SUBJECT: Supplement to Amendment Request NPF-38-249,
Extended Power Uprate
Waterford Steam Electric Station, Unit 3
Docket No. 50-382
License No. NPF-38

Response to Request for Additional Information

Figure B-12 Pressurizer Temperature Deviation for Loss of Flow Transient

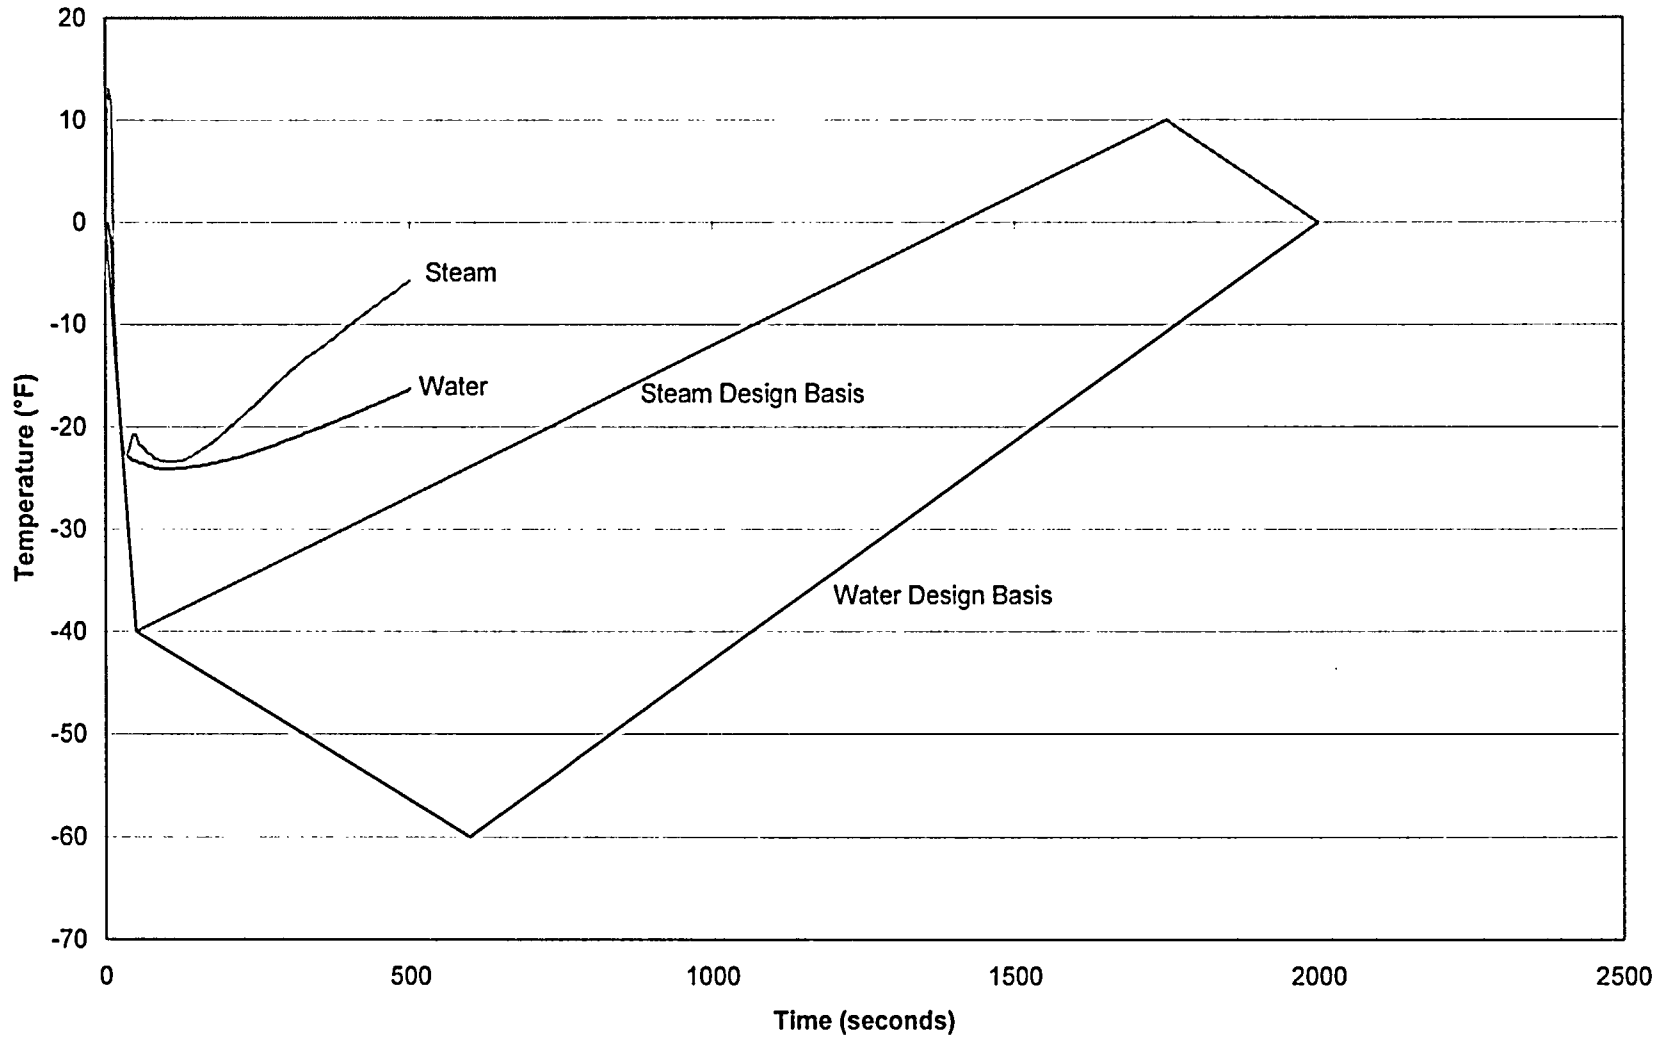
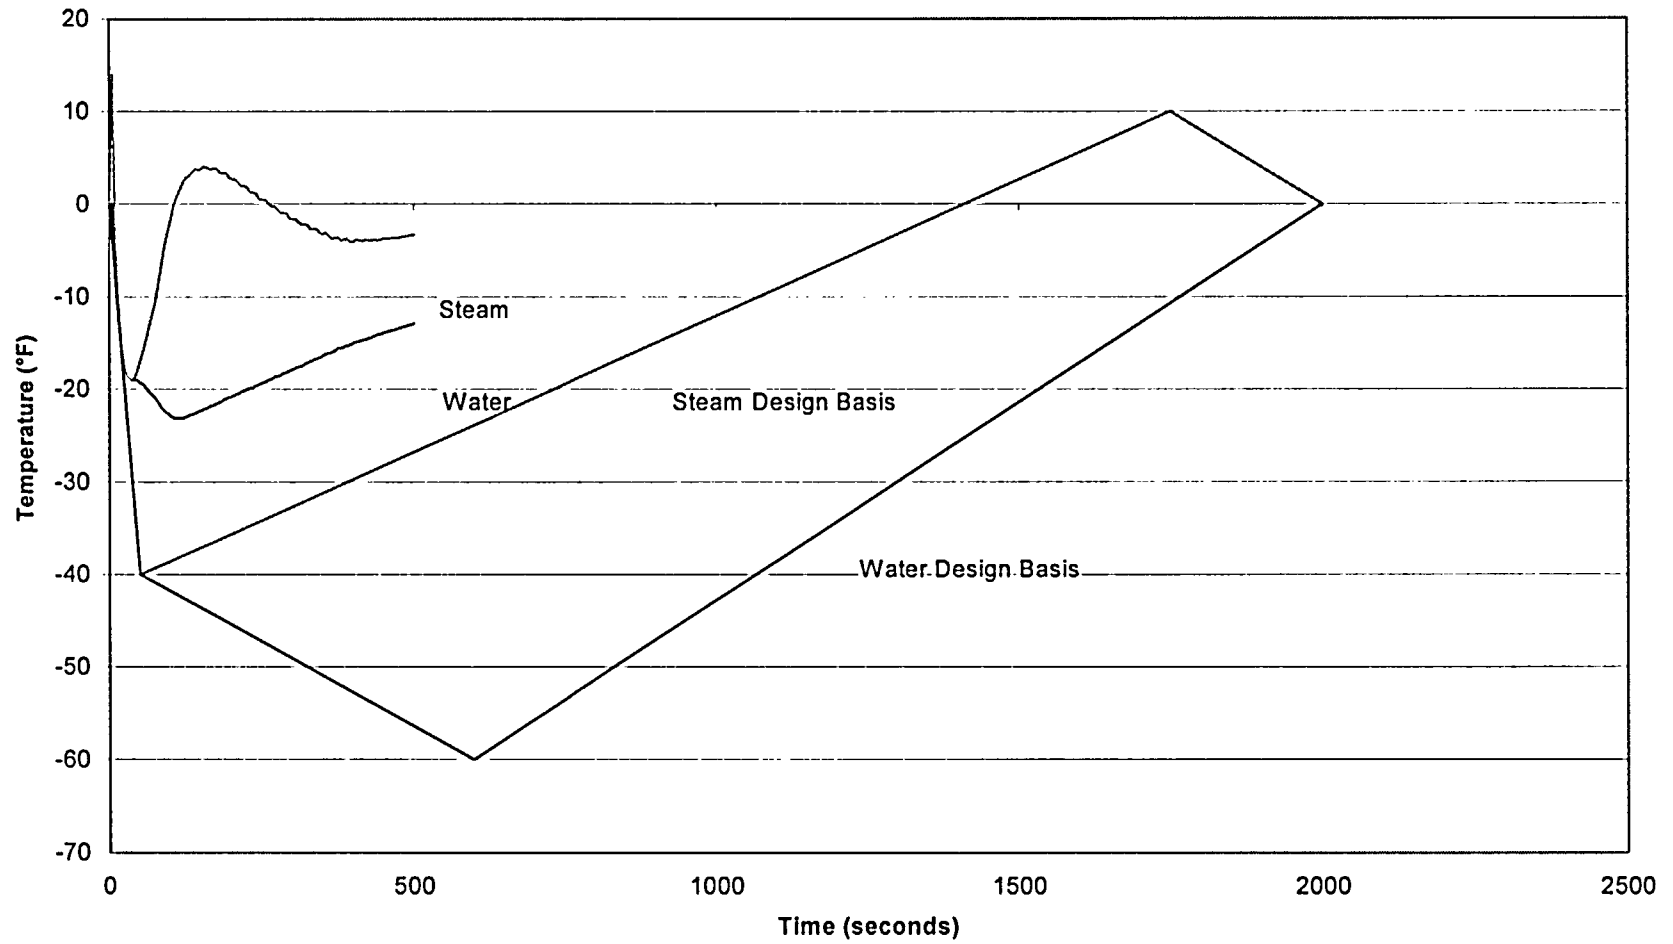
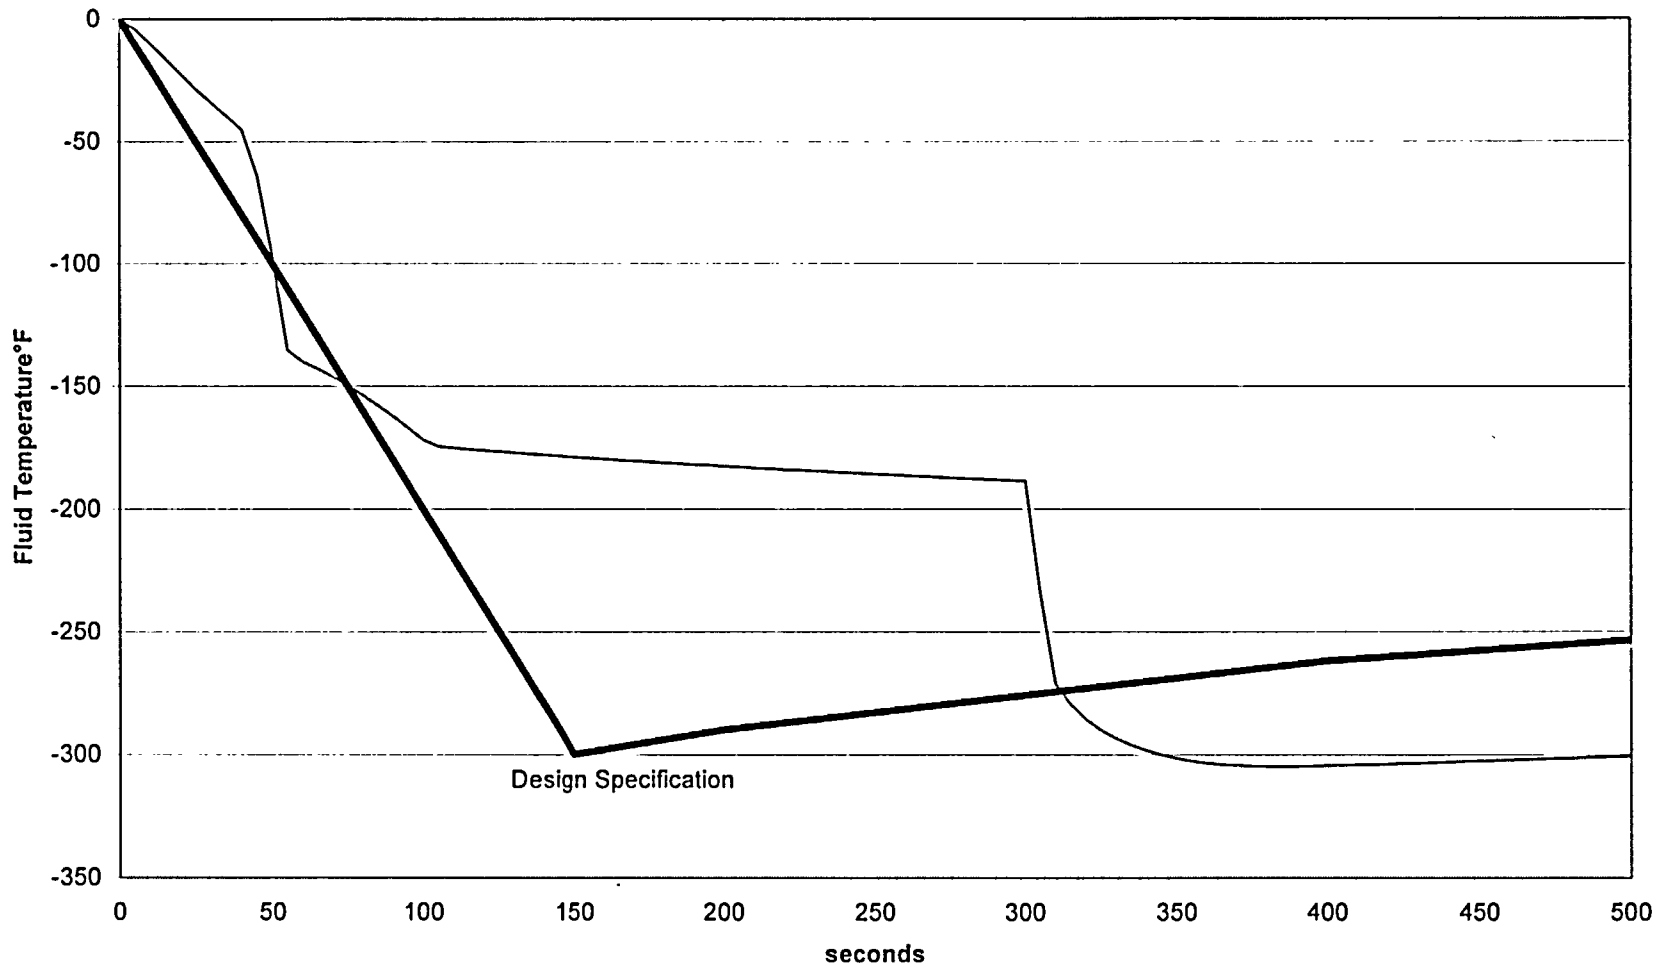
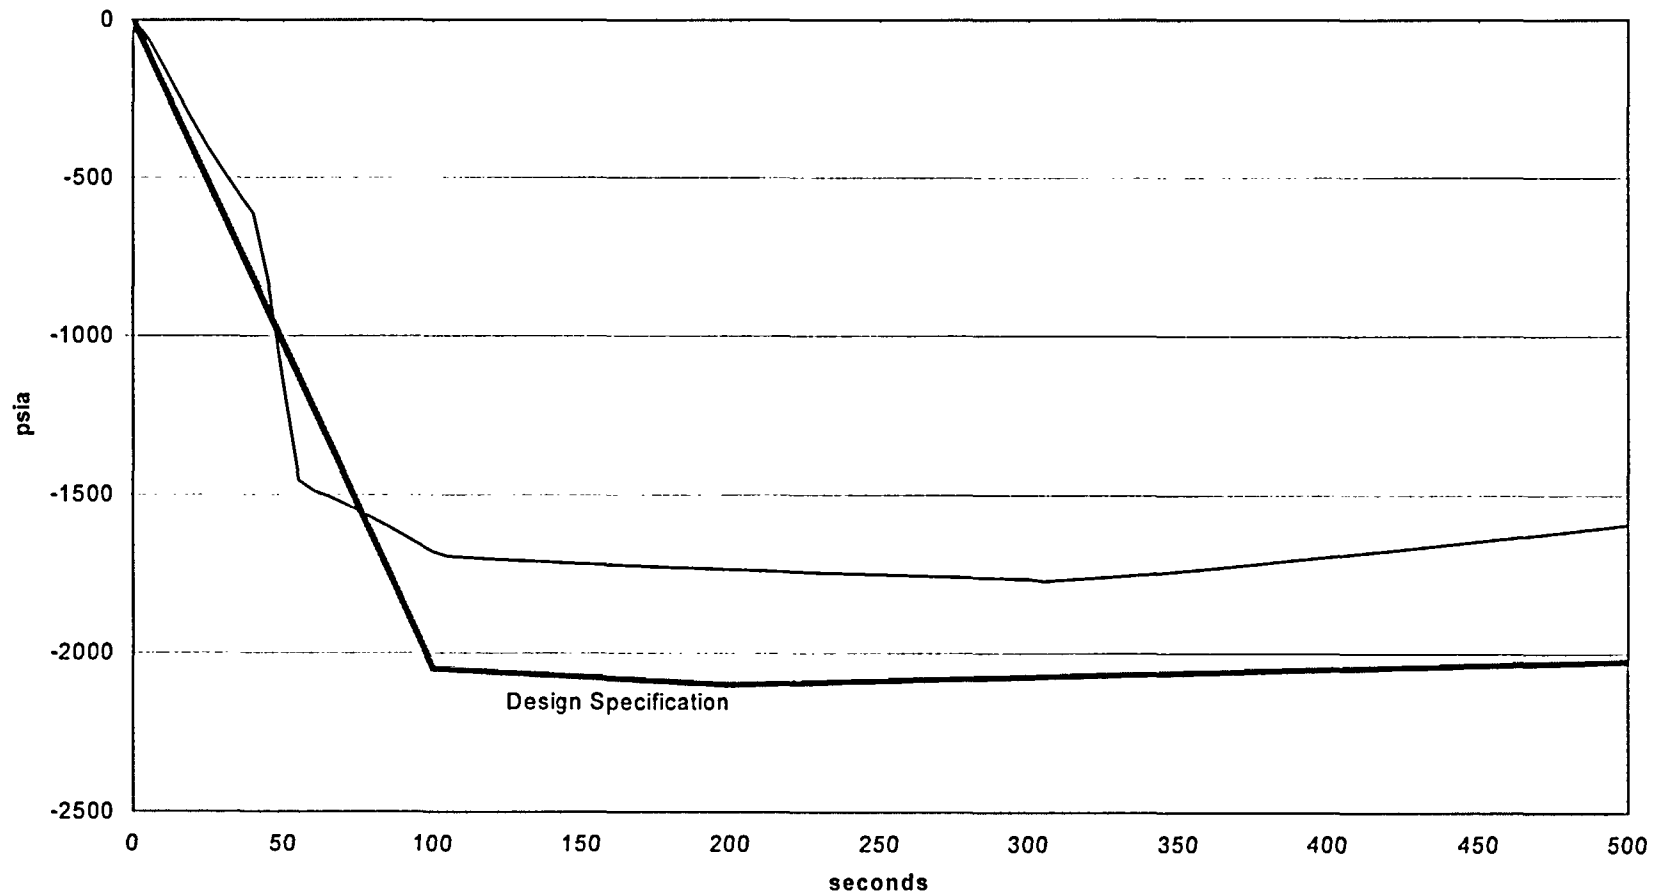
In Section 2.2.2.1.1, you indicated that power uprate resulted in minor changes to as-calculated normal operation transients, and a detailed evaluation of the changes in stresses and fatigue levels in the Reactor Coolant System (RCS) due to these transients was performed to demonstrate that the originally specified design transients for Waterford 3 remain applicable under Extended Power Uprate (EPU) conditions. This was accomplished by demonstrating that transients affected by EPU have no significant effect on the stresses or cumulative usage factors (CUFs) of the limiting RCS components. Provide a comparison of transients at the power uprate conditions to the original design-basis transients with respect to the number of occurrences and changes in pressure and temperature in the stress and cumulative fatigue usage calculations.

The originally specified design transients were evaluated for the potential effect EPU would have on them. The same list of events and number of event cycles were maintained for the EPU design transient evaluation. The Reactor Trip, Loss of Load, Loss of Flow and Loss of Secondary Pressure events were rerun using EPU conditions. The plots for the rerun cases are attached. The rerun cases and results of the evaluation were documented and evaluated for any effects on stress and fatigue levels.
